Keyless Feed Belt Pulley Upgrade

Upgrade Application

Before

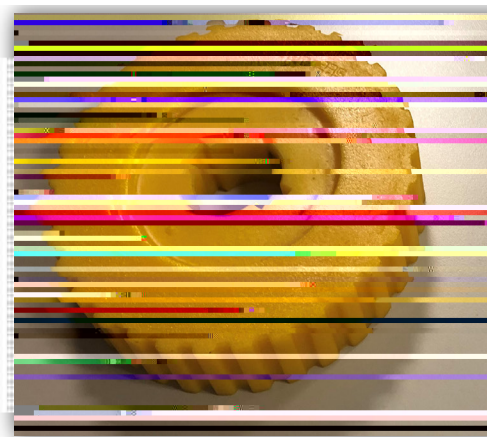
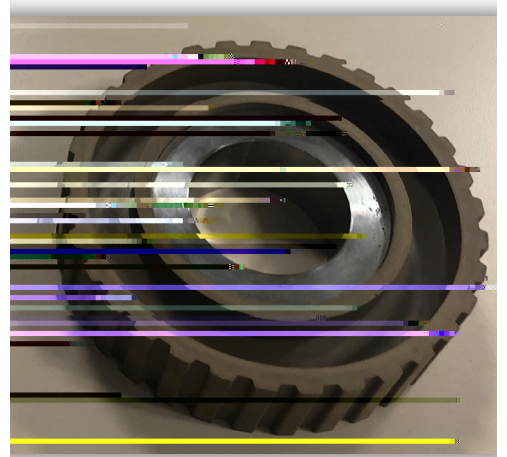
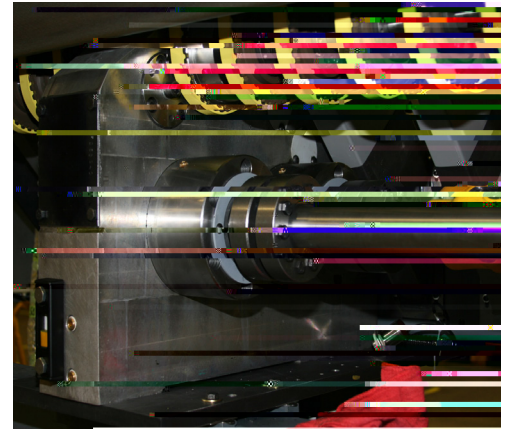
This upgrade replaces the existing plastic, keyed, timing pulleys with a new pulley designed to accept a locking element. This will eliminate the wear commonly seen with the keys. Also included is a new key-less shaft with a ringfeder center gear.

- Durable keyless pulley replaces nylon pulley
- Eliminate common key way wear by utilizing locking elements to attach pulleys to the drive shaft
- Maintains belt timing
- Increased board quality by reducing feed skew
- Reduces downtime associated with key wear
- Drop-in replacement kit includes the shaft, pulleys with locking elements, and center gear
- Very long life expectancy
